# E C O L O G I C A L   R E V I E W

**Lake Borgne and MRGO Shoreline Protection**  
CWPPRA Priority Project List 12  
State No. PO-32

Agaha Y. Brass  
Restoration Technology Section  
Coastal Restoration Division  
Louisiana Department of Natural Resources

This document reflects the project design as of the 95% Design Review meeting, incorporates all comments and recommendations received following the meeting, and is current as of July 12, 2005.

Figure 2. Estimated settlement of the foreshore rock dike on the Lake Borgne reach and the 90<sup>th</sup> percentile design wave height (USACE 2004).

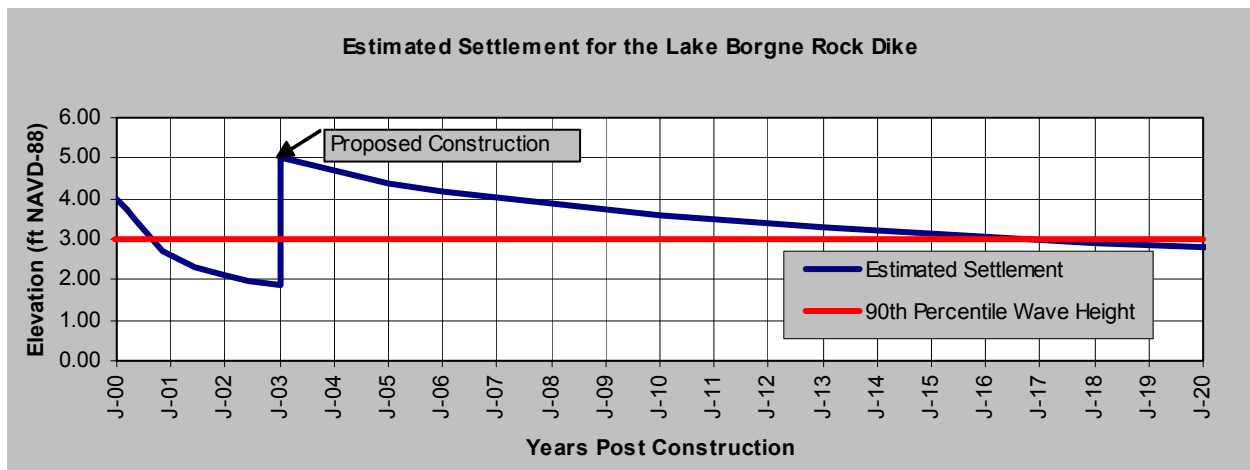
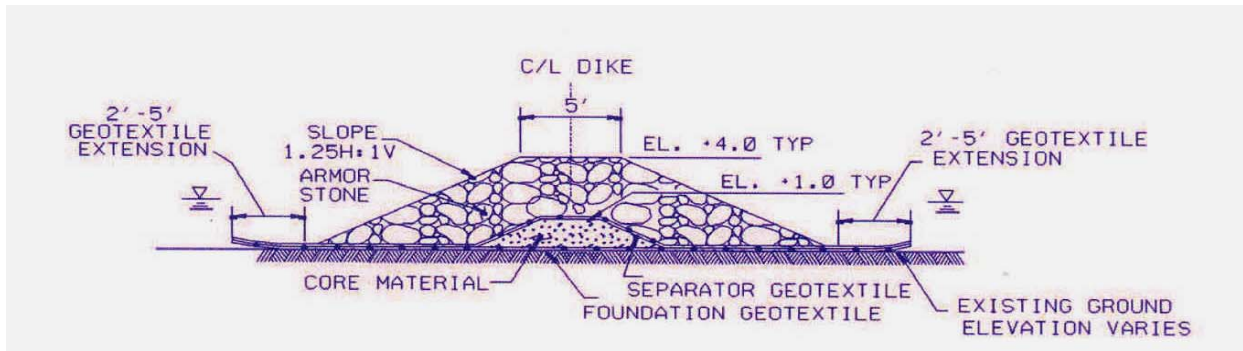
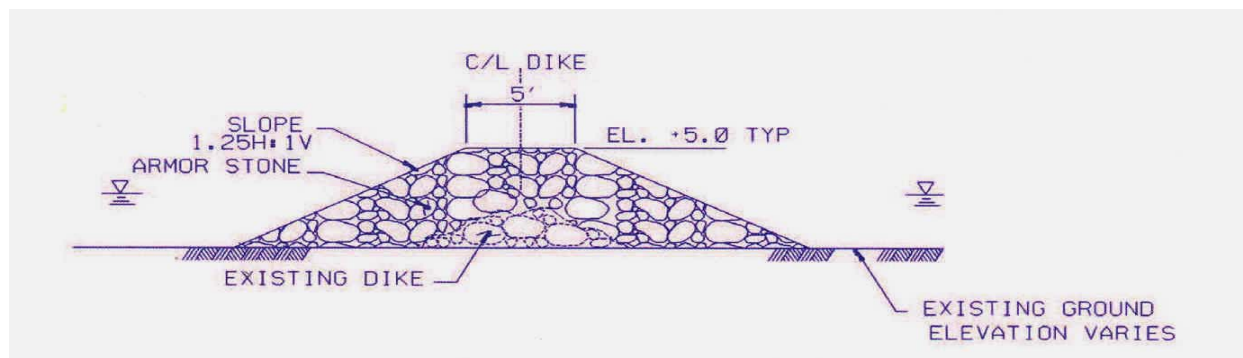
The Lake Borgne structure is a 18,820-foot foreshore composite-core rock dike constructed along the southern shoreline of the lake rim from the east bank of Doullut’s Canal to the west bank of Jahncke’s Ditch. It will initially be constructed with a top elevation of +4 feet NAVD-88 (including 1 foot of freeboard to account for settlement) and along the -2.0 foot NAVD-88 contour with a 5-foot crown width and side slopes of 1 (V) on 2 (H). The 90<sup>th</sup> percentile historical sea level statistics for the area were added to average wave height and mean high water (MHW) elevation (+1.44 feet NAVD-88) to determine a design wave height that needed to be stopped to halt erosion. An additional construction lift will be required for the Lake Borgne dike due to increased settlement rates and poor soil conditions in the area. It is estimated that the dike will settle approximately 2 feet in 3 years after which a construction lift will be applied. This lift should sustain the dike’s effectiveness for the bulk of the remaining project life (Figure 2). Details of the construction lift are shown in the plans and specifications.

**Figure 3. Typical dike section for first construction lift on MRGO (USACE 2004).**

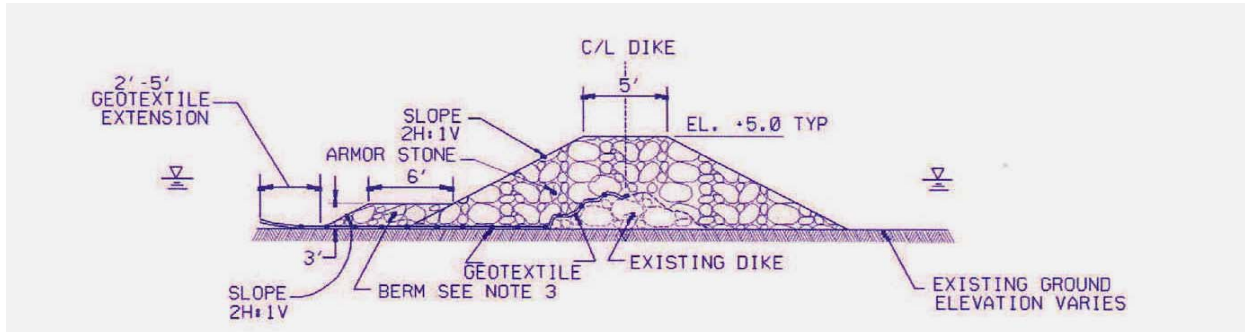
The second structure is a 14,360-foot foreshore composite-core rock dike constructed along the north shore of the MRGO from the east bank of Doullut's Canal to the west bank of Lena Lagoon. It will initially be constructed with a top elevation of +4 feet NAVD-88 (3-foot minimum elevation to block 90<sup>th</sup> percentile waves with a 1 foot freeboard to account for settlement), with a 5-foot crown, and side slopes of 1 (V) on 1.25 (H) (Figure 3). Based upon subsurface soil conditions and previous construction experience in the project area, the USACE recommends that the rock breakwater along the MRGO be built in a series of three construction lifts. This multi-lift construction plan will allow soils in the project area to adjust to the weight of the breakwater materials over time and will result in better performance and lower long-term operation and maintenance costs for the project.

Figure 7. Estimated settlement on the MRGO reach vs. the 90<sup>th</sup> percentile design wave height (USACE 2004).

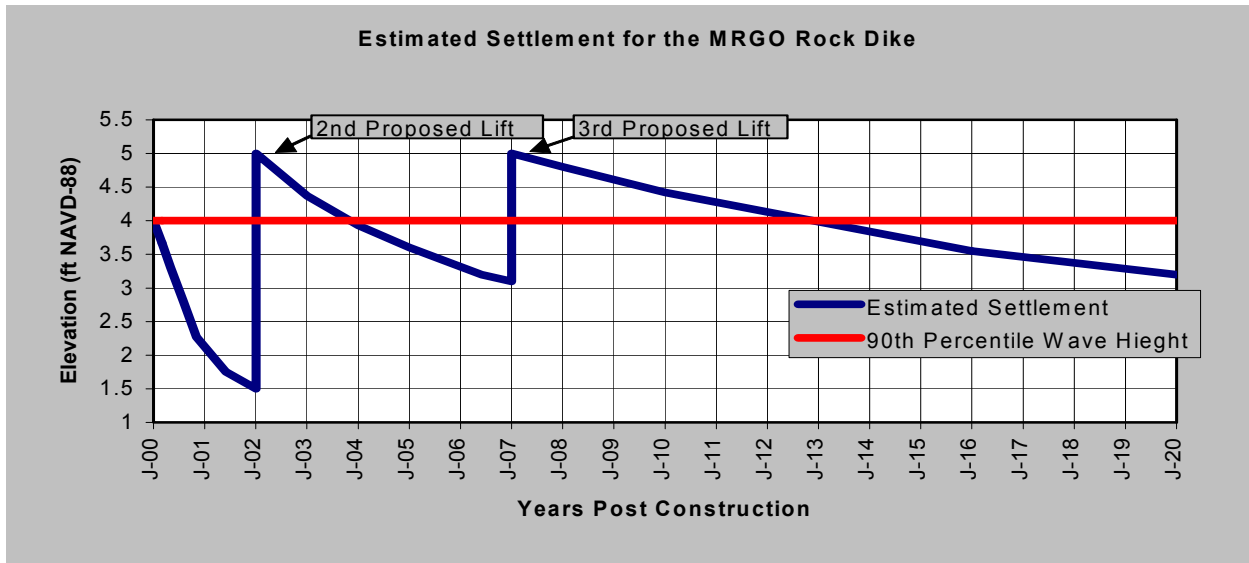
It is estimated that the dike will settle approximately 2 feet in the first year with a cumulative settlement of 3 feet in the first two years (Figure 7). The third and final construction lift will include a channel side berm. This berm will be 3 feet high and 6 feet wide with a side slope of 1 (V) on 2 (H) overlain on geotextile material, and it will be used to reduce the amount of launching should the toe of the structure become compromised (USACE 2004). The MRGO structure will not attain its final height until the second and third construction lifts have been constructed and the dike settlement rates have reached equilibrium. Additional analyses were conducted to determine if the elevation of the lifts could be lowered and to determine if coordinating the timing of the Lake Borgne and MRGO 2<sup>nd</sup> construction lifts were feasible. It was determined that coordinating the lifts, such that they occur on both project reaches at the same time, did not result in any additional project benefits or cost savings. The elevation of the construction lifts would have been lowered to +4 feet NAVD-88 from +5 feet NAVD-88, but the results showed that lowering the elevation meant adding an additional operations and maintenance (O&M) lift later in the project life. The structure will need a maintenance lift after year thirteen to account for additional settlement that will occur beyond that point.

**Figure 8. Estimated settlement of the created marsh behind the structures on Lake Borgne and the MRGO.**

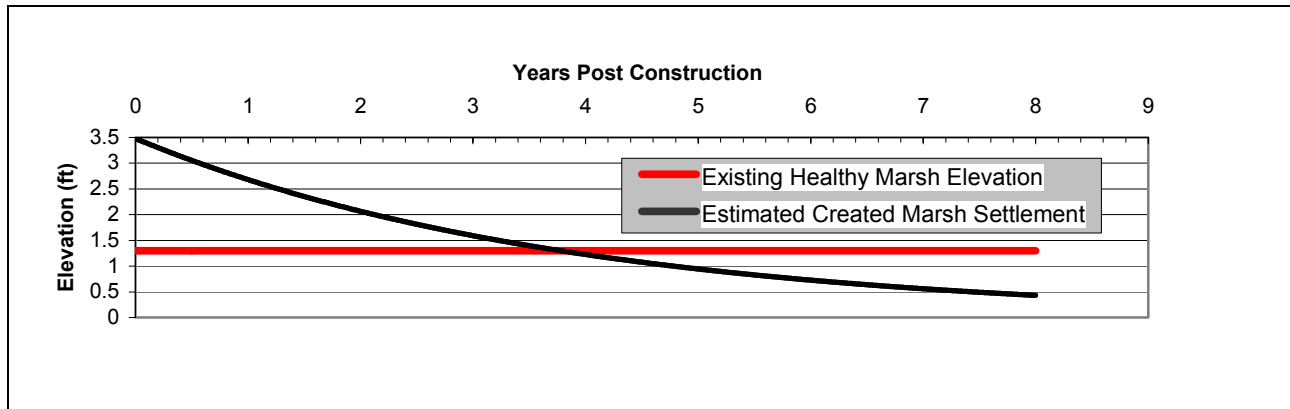
Dredged material from the flotation channel (80-foot maximum bottom width) will be stacked to a maximum of +3.5 feet NAVD-88 and is expected to de-water down to an elevation similar to that of existing marsh conditions. Approximately 315,000 cubic yards of material will be available from the Lake Borgne flotation channel and 189,000 cubic yards from the MRGO channel which will initially create approximately 43 and 26 acres of marsh, respectively. The fill will be held 10 feet from the landward toe of the structure to minimize adverse impacts on the soils in close proximity of the foreshore structure (USACE 2004). Settlement analysis and calculations for the material have shown that the created marsh will be at or below 0.5 feet NAVD-88 by TY08 and settles below the existing healthy marsh elevation by TY04 (Figure 8).
